Addendum No. 1

West 7th Street Tank Replacement

Bid # 0910-173
TMWA Project No. 05-027
January 4, 2010

Title
IRRIGATION PLAN
ADDENDUM 1 - ATTACHMENT A

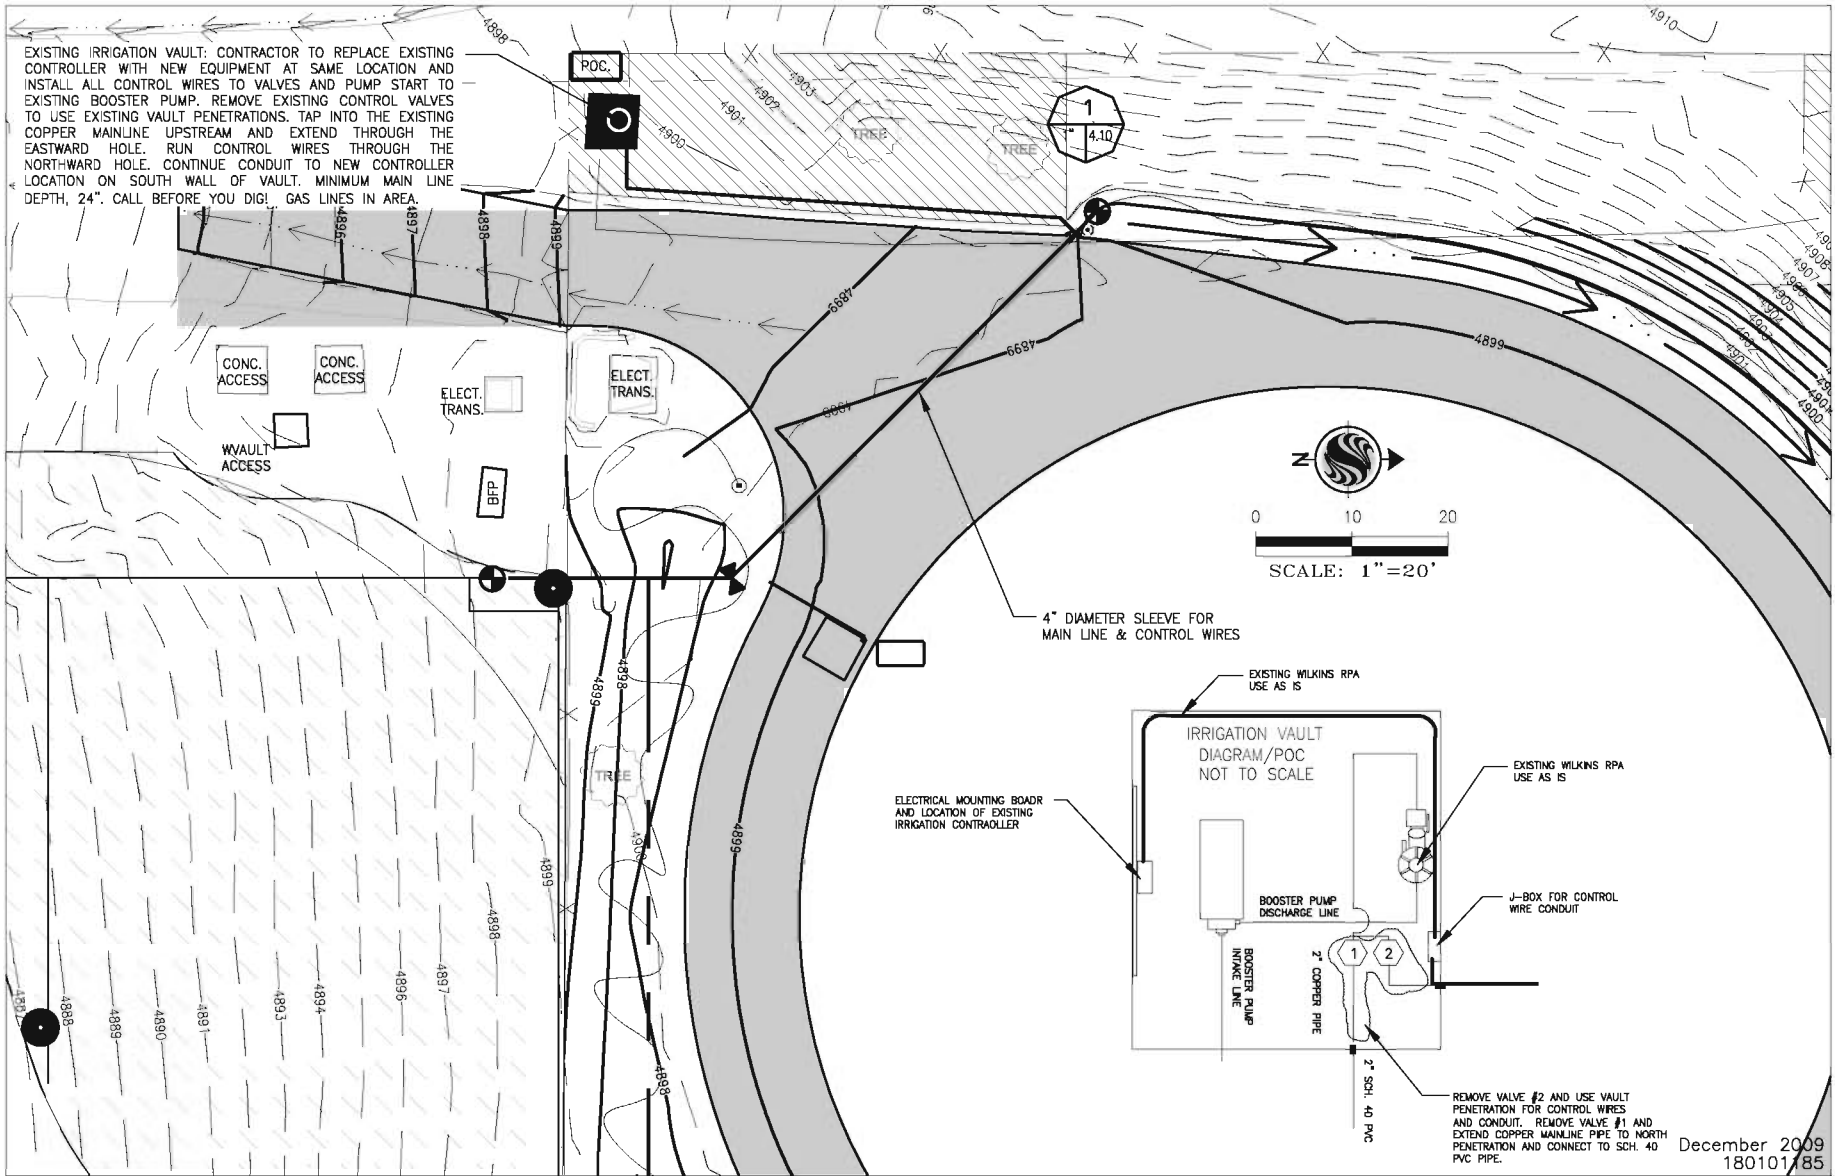
1. The following changes shall be made to the Irrigation sheets. Attachment A shows the new configuration for the point-of-connection (POC) of the irrigation system.

- a. Connect new main to existing POC at the existing vault located in the southwest corner of the lot in Gas Lease Area, west of lot entrance gate. Make all upgrades to meet local codes as required at this location

- b. Mount new irrigation controller on wall of the existing vault located in the southwest corner of the lot in Gas Lease Area, west of lot entrance gate. Electrical sweep for irrigation control shall be per electrical sheets. Verify capability of adding to 120V power source and meet all local codes. Final controller mounting location to consider wire and maintenance accessibility, and be approved by TMWA prior to construction.

- c. Emitter Schedule. Delete emitter schedule for shrubs and replace with
 - 2 - 2 gph emitters for each #5 shrub
 - 2 - 1 gph emitters for each #1 shrub
